**MINERALS PROGRAM INSPECTION REPORT**  
**PHONE: (303) 866-3567**

<b>MINE NAME:</b> Dowe Flats Mine	<b>MINE/PROSPECTING ID#:</b> M-1993-041	<b>MINERAL:</b> Limestone and shale	<b>COUNTY:</b> Boulder
<b>INSPECTION TYPE:</b> Monitoring	<b>INSPECTOR(S):</b> Amy Eschberger	<b>INSP. DATE:</b> November 5, 2019	<b>INSP. TIME:</b> 14:30
<b>OPERATOR:</b> CEMEX, Inc.	<b>OPERATOR REPRESENTATIVE:</b> Cita Cisse, Scott Harcus, Robin Bay	<b>TYPE OF OPERATION:</b> 112c - Construction Regular Operation

### **Technical Revision No. 2 (Updated Mining and Reclamation Plans; Approved October 22, 2009):**

FIGURE 4: TYPICAL CROSS SECTION OF QUARRY CONFIGURATION AND ROCK UNITS TO BE MINED

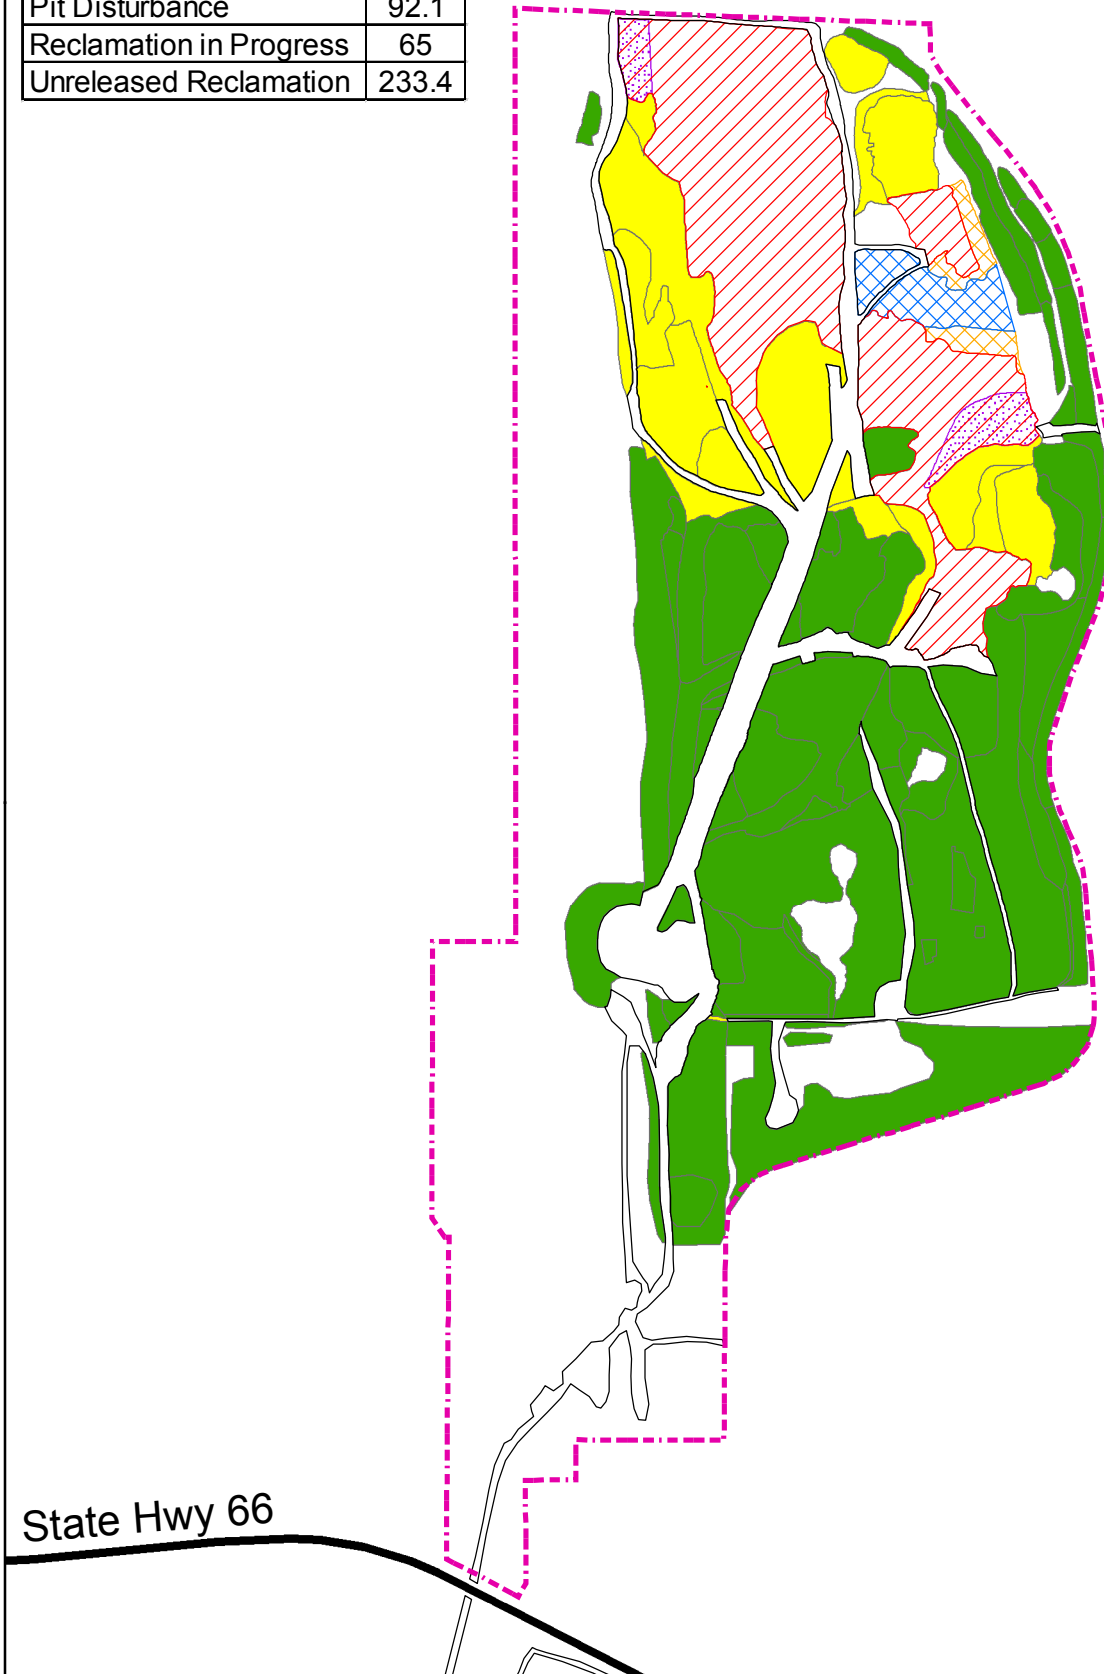
This is a 112c operation permitted for 1,854.45 acres to mine limestone and shale for use in the operator's cement plant (Lyons Quarry; Permit No. M-1977-208), located just south of this site, on the other side of Hwy 66. Four horizons have been targeted for mining at this site based principally on their calcium carbonate content and utilization potential at the cement plant. The west limb of a southward plunging syncline contains the four beds of interest; all outcrop along a general north-south strike and exhibit gentle dips to the east. The four ridges overlap due to the stratigraphic superposition of the limestone beds. The western-most seam (also stratigraphically the lowest) is referred to as the Hi-Cal Ridge. Expressions of the other horizons are more subdued and these are known locally as the 2<sup>nd</sup>, 3<sup>rd</sup>, and 4<sup>th</sup> Ridges (see enclosed Figure 4: Typical Cross Section of Quarry Configuration and Rock Units to be Mined, received with TR-2 on May 26, 2009).

Red Outline = 1,854.45 acres = Approved Permit Area (location approximated based on approved maps in permit file)  
(Image data from 5/31/2018)

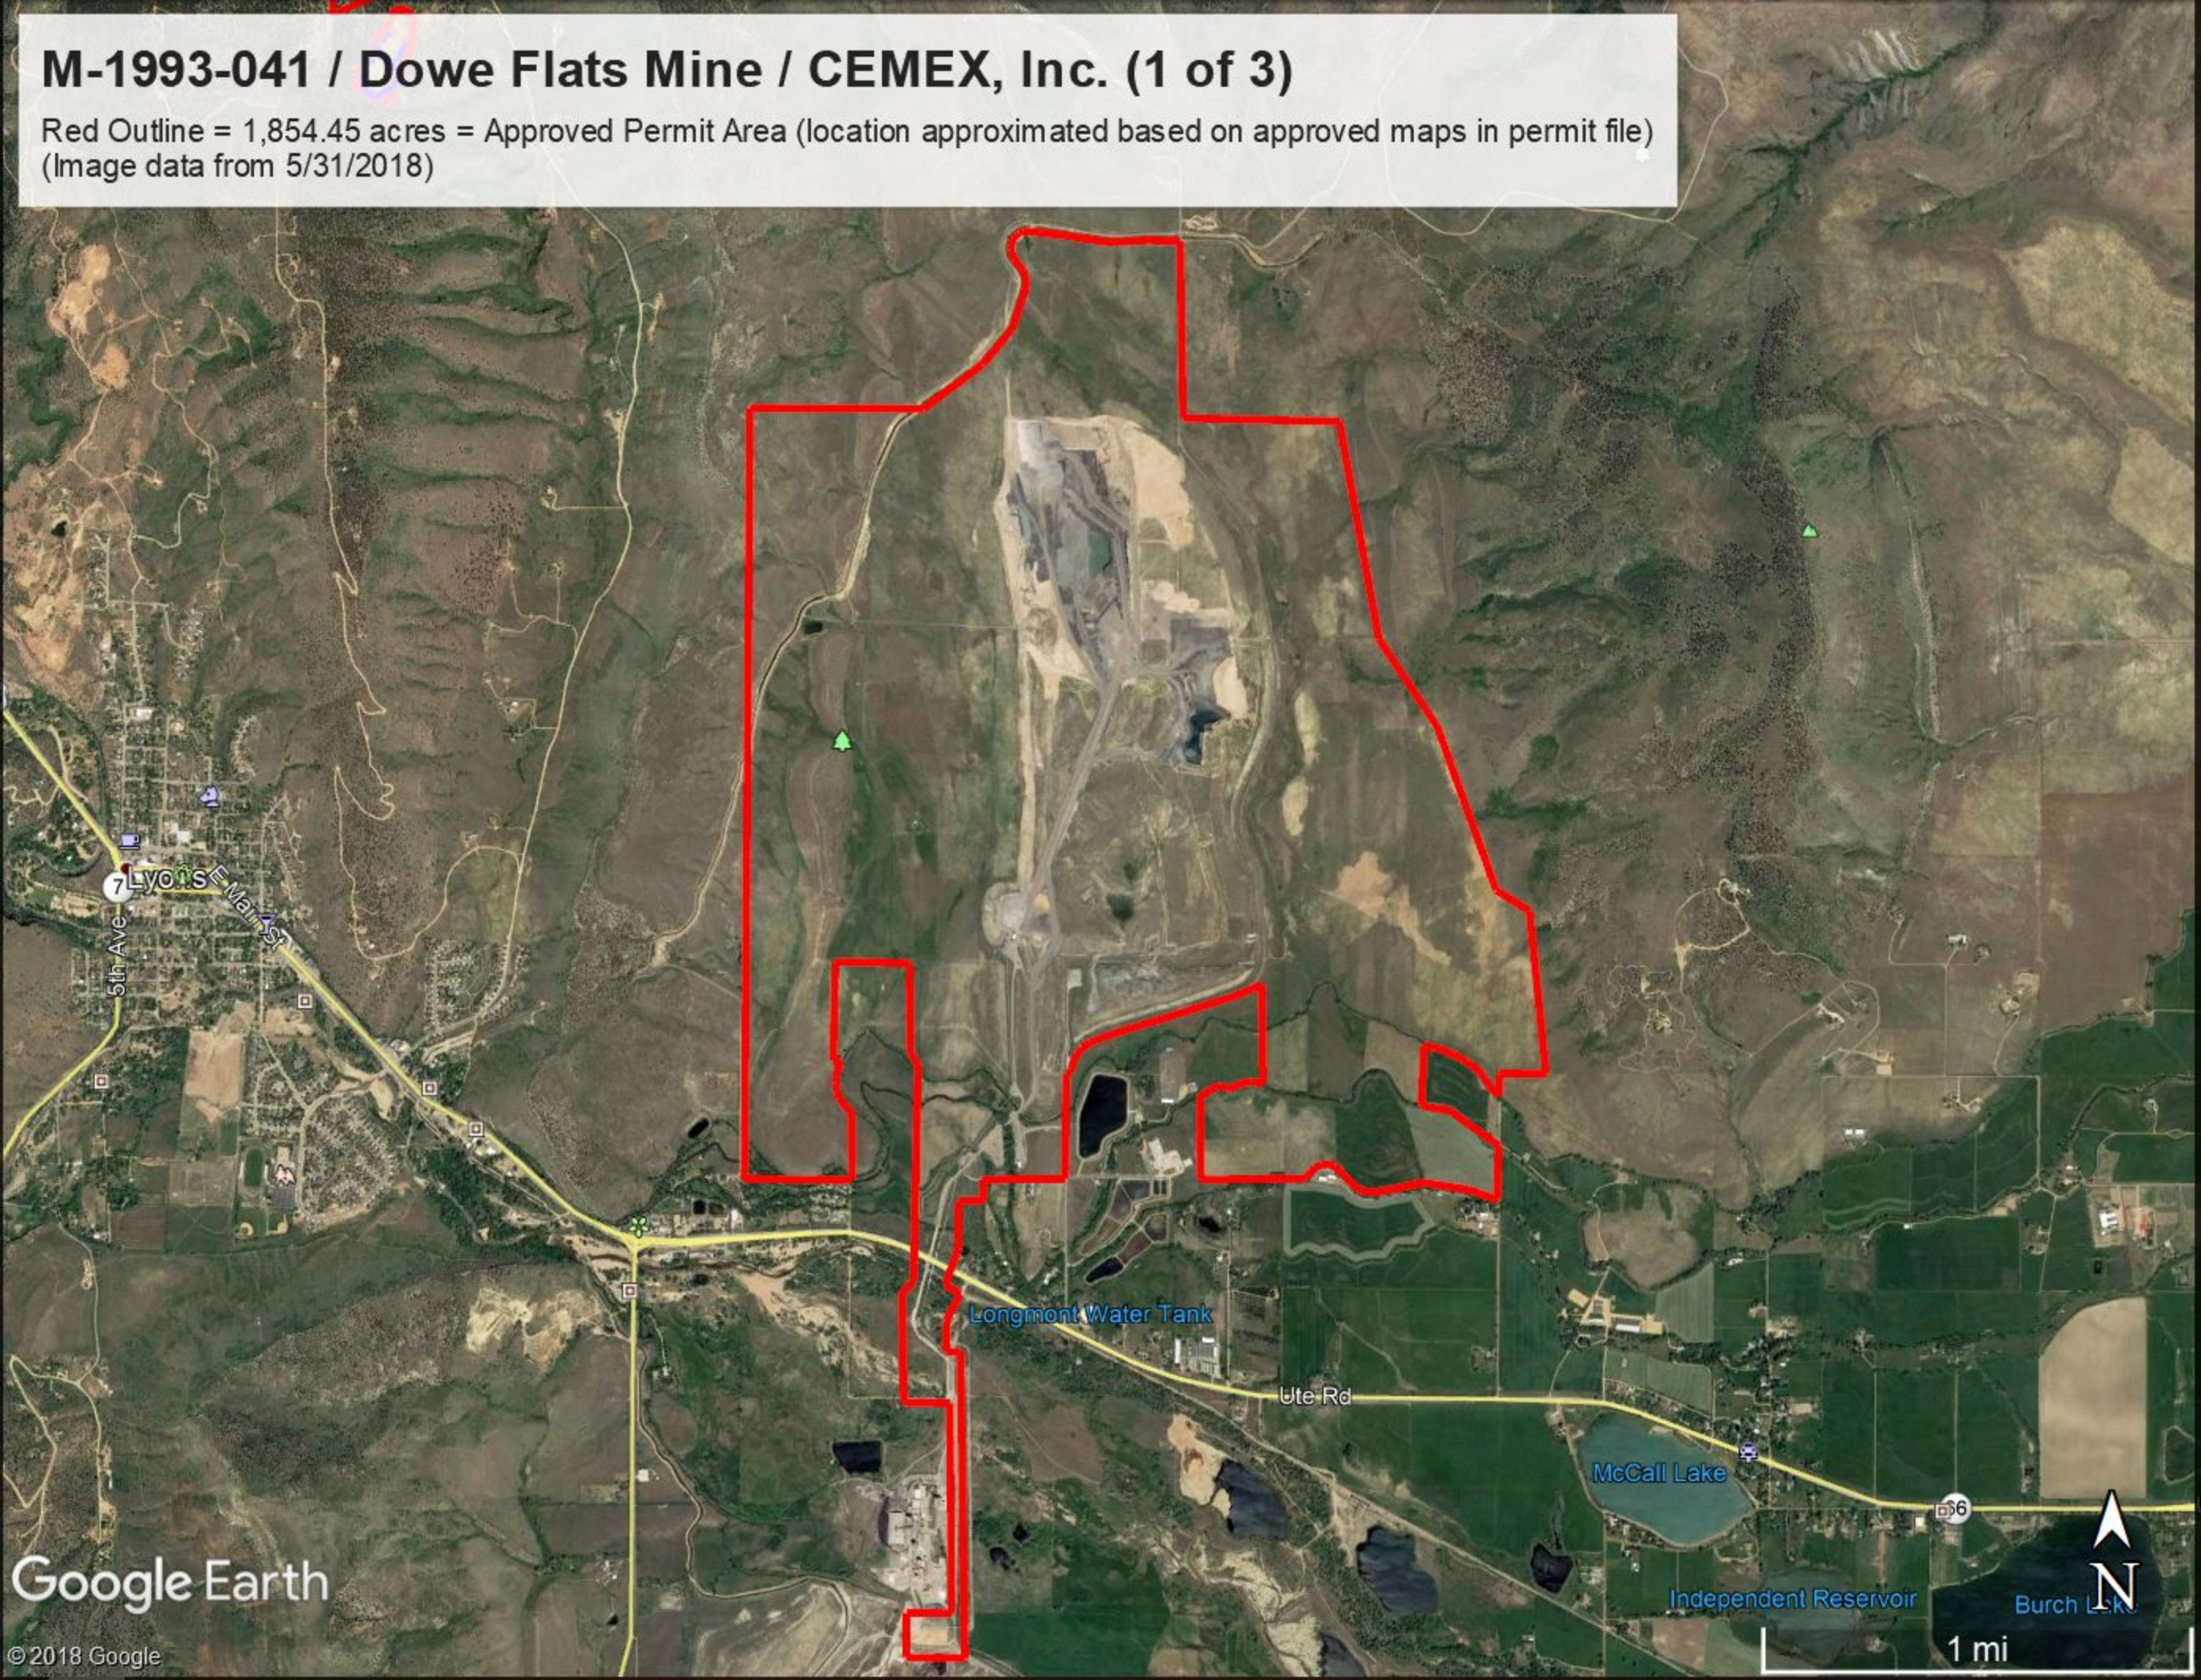
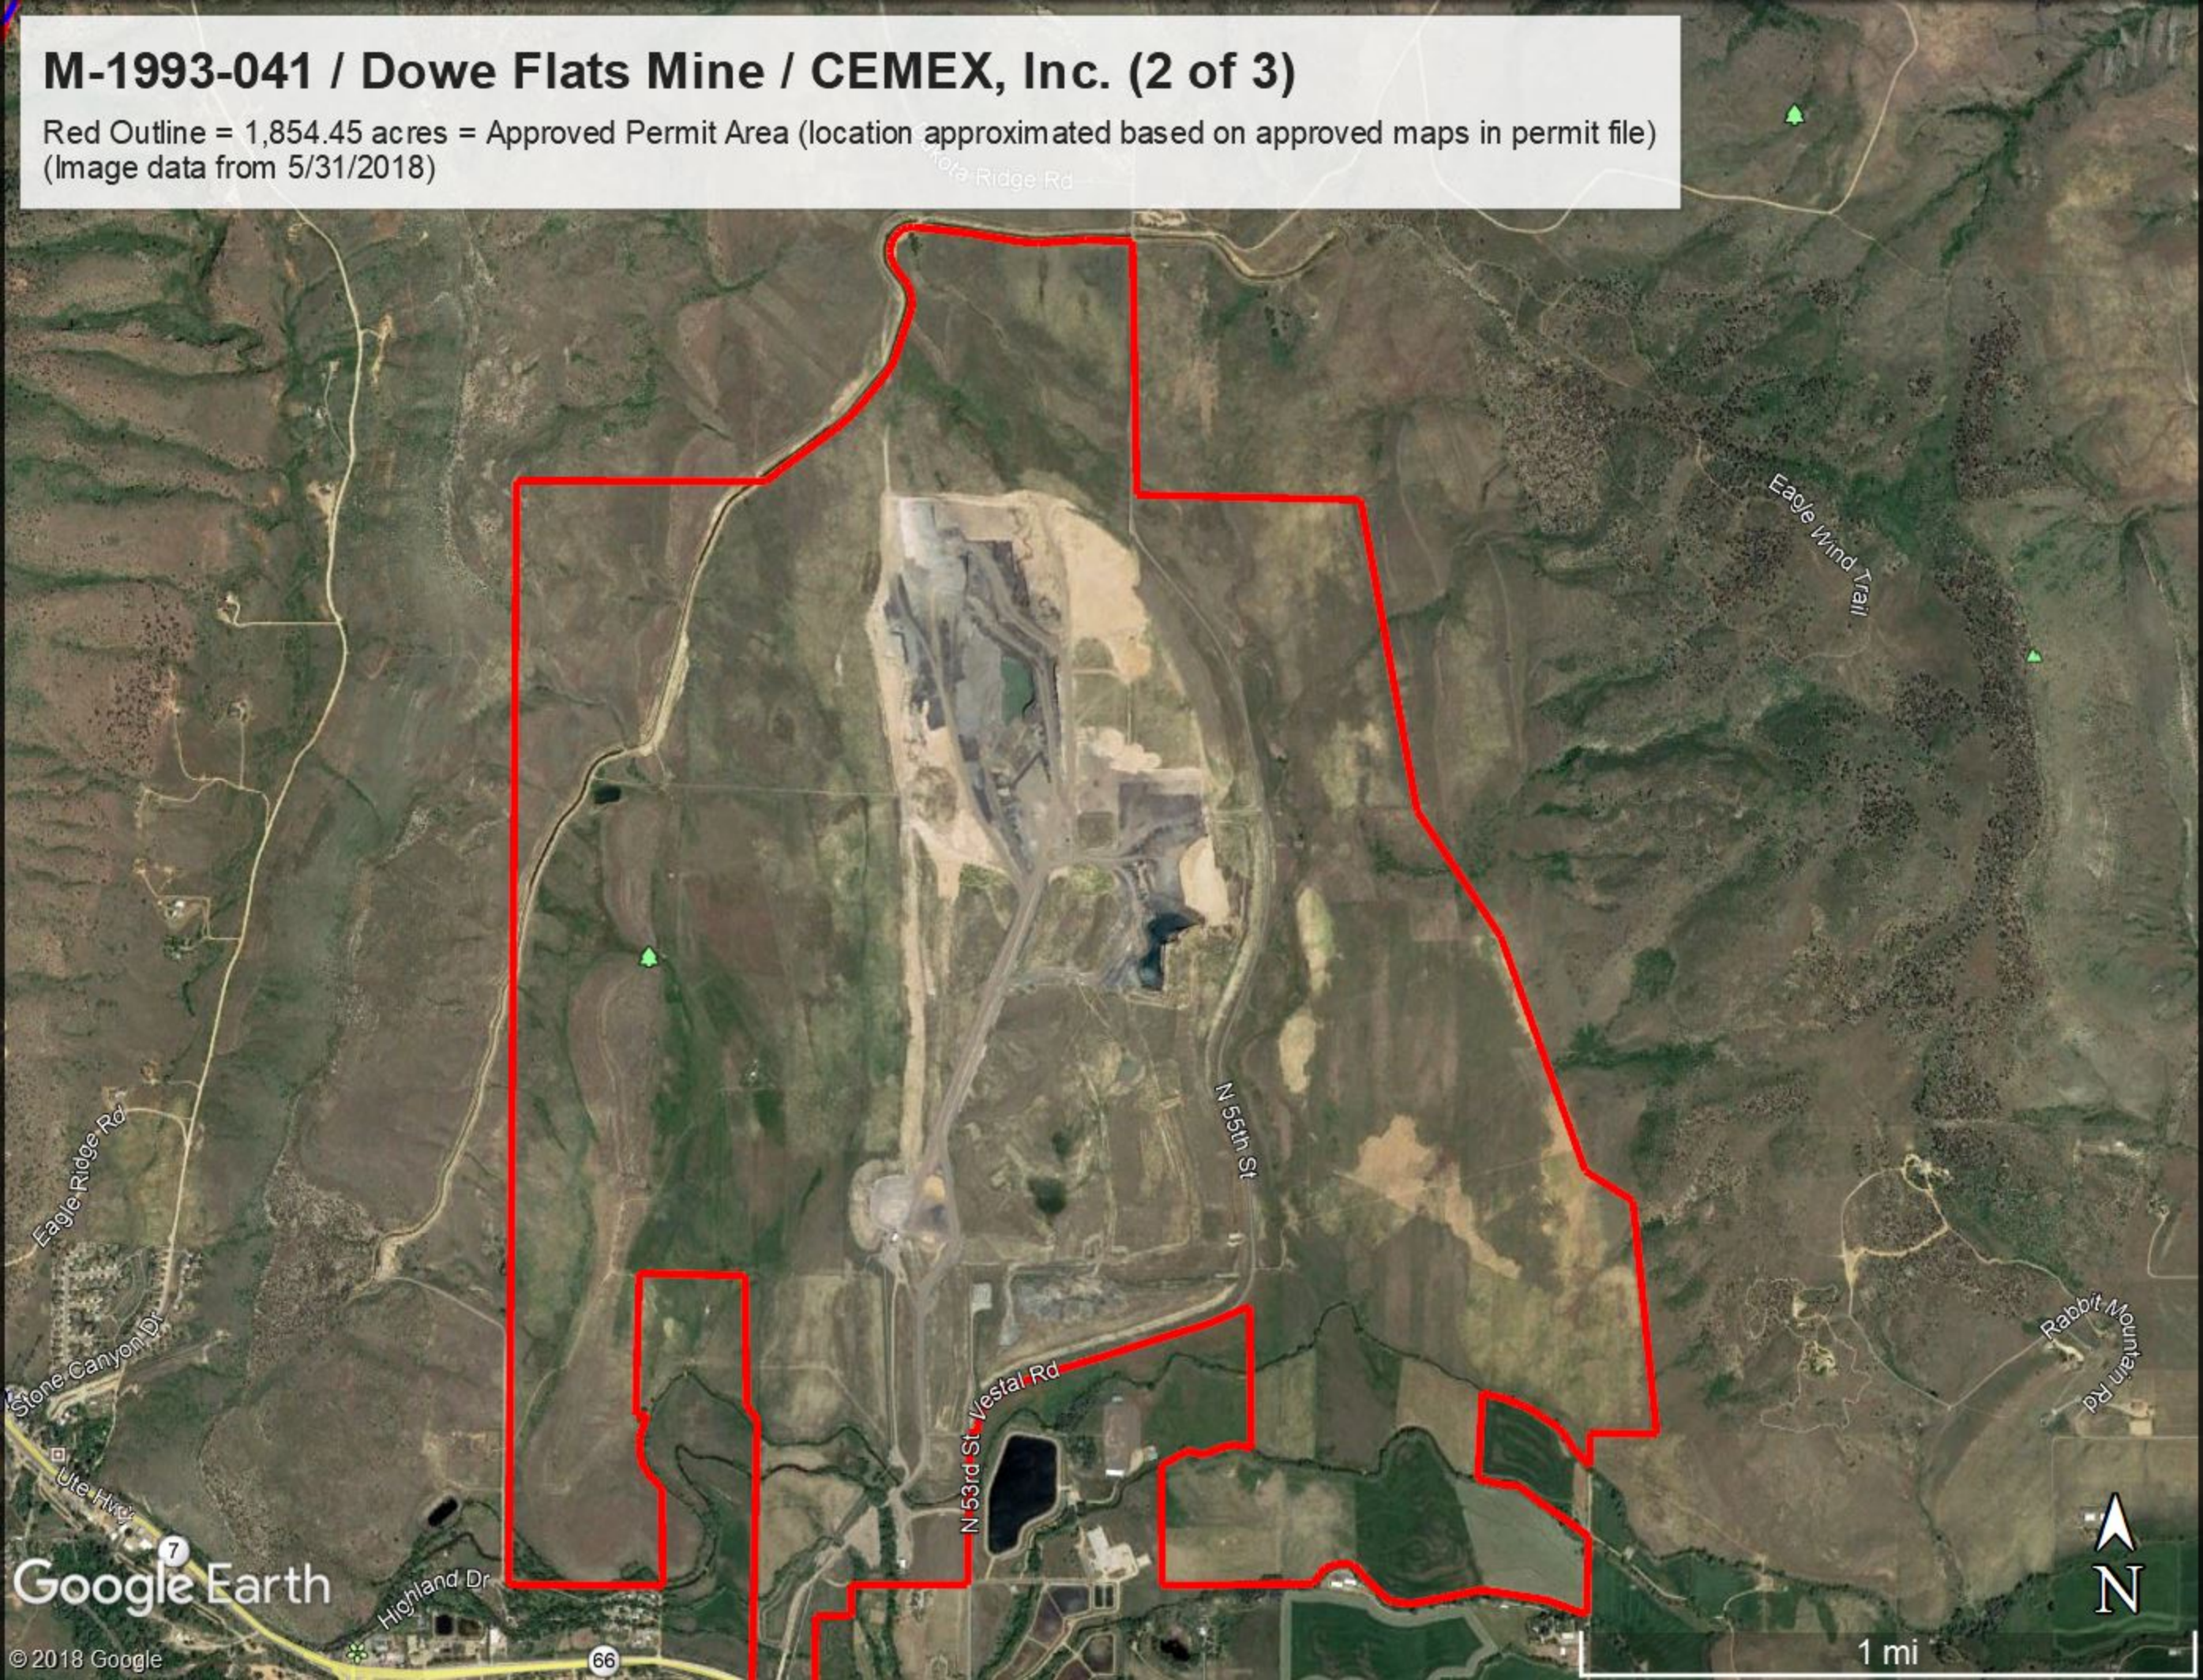
The Division was unable to find updated mining and reclamation plan maps in the permit file which depict the entire approved permit boundary and affected land boundary, particularly the portion located south of Hwy 66. Therefore, the operator will need to provide updated mining and reclamation plan maps for the site that meet the requirements of Rules 6.2.1(2), 6.4.3, and 6.4.6 (see enclosed rules). These maps should depict both the approved permit boundary (comprising 1,854.45 acres) and the affected lands boundary (comprising 464.9 acres). These updated maps should be submitted with the Technical Revision required for Problems #1 and #2 cited in this report (see pages 1 and 2). Enclosed with this report are a total of 12 site maps that were submitted with the original application, AM-1, AR-1, AR-2, and TR-2, which the operator may find useful. Also enclosed with this report are Google Earth images 1-3 of the site showing what the Division believes to be the approved permit area based on the approved maps in the permit file.

- c) Provide an updated mining plan map that depicts the entire approved permit boundary and affected lands boundary (including areas south of Hwy 66), and meets the requirements of Rules 6.2.1(2) and 6.4.3.

- d) Provide an updated reclamation plan map that depicts the entire approved permit boundary and affected lands boundary (including areas south of Hwy 66), and meets the requirements of Rules 6.2.1(2) and 6.4.6.
